Subject: South Carolina Electric & Gas Company  
Urquhart Generating Station  
Coal Combustion Residue Impoundment  
Round 9 – Dam Assessment Report (April 2011)

**Coal Combustion Residue Impoundment  
Round 9 - Dam Assessment Report**

*Urquhart Generating Station*  
*Ash Ponds*  
*South Carolina Electric & Gas*  
*Beech Island, South Carolina*

Subject: EPA Comments on South Carolina Electric & Gas Co, Urquhart Generating Station, Beech Island, SC  
Round 9 Draft Assessment Report

Figure 2.1b: Urquhart Generating Station Aerial View

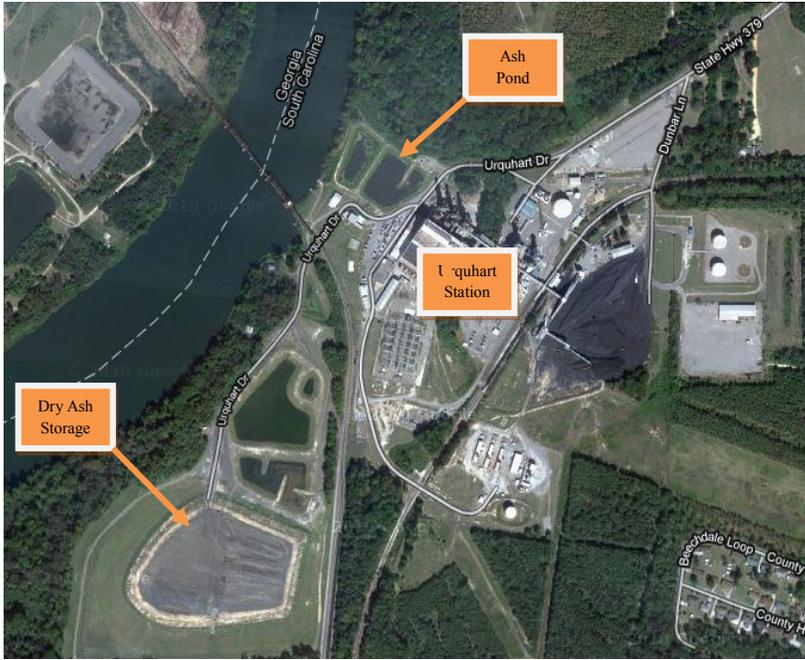
**Comment [wra1]:** Note – Arrows were pointing to the wrong places. Descriptions and arrows of ash pond, dry ash storage and Urquhart Station are moved to point at the correct item.
